Technical Bulletin

TB No. AA-17067 No Revision June 1, 2017

BELL 412EPI STC PLACARD UPDATE PER LATEST RFMS AA-

11045 REV D

Figure 4

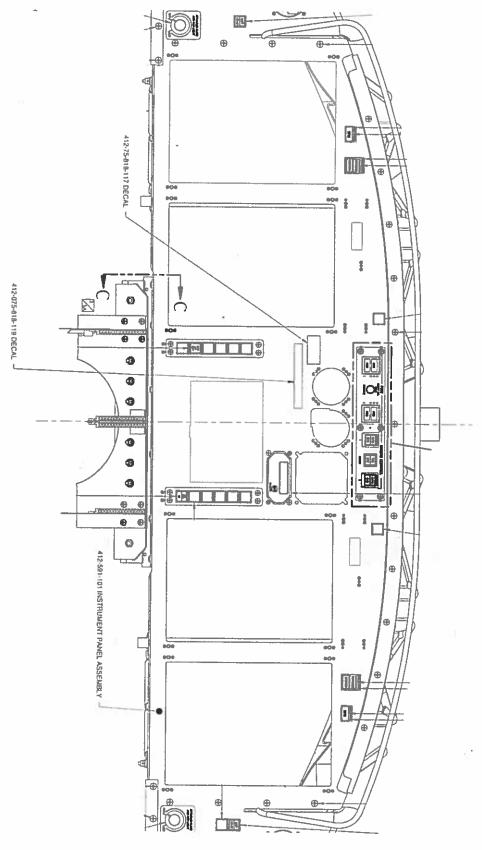
1. Inspect aircraft instrument panel to determine if decal P/N: 412-075-818-117 (Figure 1) is installed. Refer to Figure 4 for location of decals.

- 2. If P/N: 412-075-818-117 decal is not present, install it as shown in Figure 4.
- Inspect aircraft instrument panel to determine if decal P/N: 205-070-159-001 (Figure 2) is installed.

If decal P/N: 205-070-159-001 is installed, remove decal and retain for return to Aeronautical Accessories. Replaced removed decal with decal P/N: 412-075-818-119 (Figure 3) as shown in Figure 4.
